**Report: PRELIM**

**Function: Test, Adjust, & Balance**

## **12-11-23 FORT LEE RESTAURANT - FORT LEE, NJ**

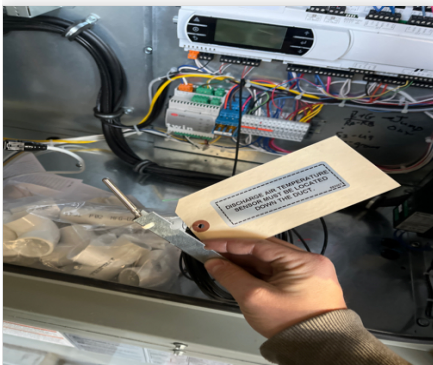
**Issue Name :** DOAS: Bad relay  
**Description :** Relay R7 is bad and will need to be replaced. Diagnosed with ACCUREX tech support. Contact accurex for warranty replacement care number: G-106054-T1Y5G7  
**Created By :** National TAB                      **Assigned To :** National TAB - Tyler Youells  
**Status :** Open  
**Priority :**                                              **Asset Tag :**  
**Originated Date :** 12/18/2023 - Tyler Youells - National TAB

**Controlbox**  
12/13/2023

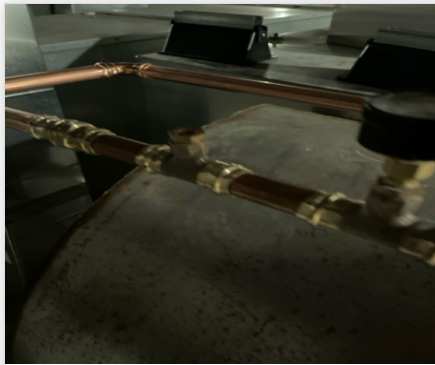
**Issue Name :** PCU- Wash system not installed  
**Description :** Wash system for static filters has not yet been installed. Control box not landed, piping(not fully) detergent bottle, not yet installed.  
**Created By :** National TAB                      **Assigned To :** National TAB - Tyler Youells  
**Status :** Open  
**Priority :**                                              **Asset Tag :**  
**Originated Date :** 12/13/2023 - Tyler Youells - National TAB
